Wilcot Road,
Pewsey

Addendum Surface Water Drainage Strategy

Dunmoore Group

LLFA Consultation Response for Planning Application PL/2025/02647

Drawing: **2501057-0500-01** Revision: **P05**

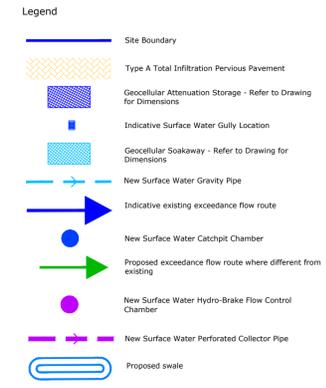
- A detailed drainage strategy layout that includes labels for pipes and nodes, corresponding to detailed drainage calculations.
- Drainage calculations demonstrating no flooding on site for a 1 in 30 year rainfall event.

- Evidence that all infiltration devices have been sited an appropriate distance from any building/ road/ unstable land. Building Regulation Part H states that the minimum clearance is 5m.

- Cross section drawings and drainage details for all attenuation, infiltration and conveyance SuDS features.
- Detailed overland exceedance routes for flows in excess of the 1 in 100 year plus climate change rainfall event.

- 2.1 The changes to the Site Layout Plan in **Appendix B** have reduced the proposed impermeable area from 0.555 ha to 0.496 ha.
- 2.2 The updated surface water drainage strategy still includes Type A total infiltration pervious pavements and a geocellular soakaway sized based on an infiltration rate of 4.09×10^{-5} m/s and a factor of safety of 5. However, additional conveyance swale areas have now been integrated into the strategy to collect and convey runoff from the proposed road, utilising the additional soft landscaped area available along the western boundary of the site. At the reserved matters planning stage, individual plot geocellular soakaways can also be added to the surface water drainage strategy where viable.
- 2.3 The updated surface water drainage strategy can be seen in **Appendix C** of this report.

- 2.13 The Surface Water Drainage Strategy is based on preliminary levels and is subject to detailed design.
- 2.14 With regards to exceedance flows, overall, the site levels will continue to slope as existing, and the proposed SuDS will integrate with the function of the natural drainage systems. Exceedance flow arrows are shown on the surface water drainage strategy in **Appendix C** of this report.
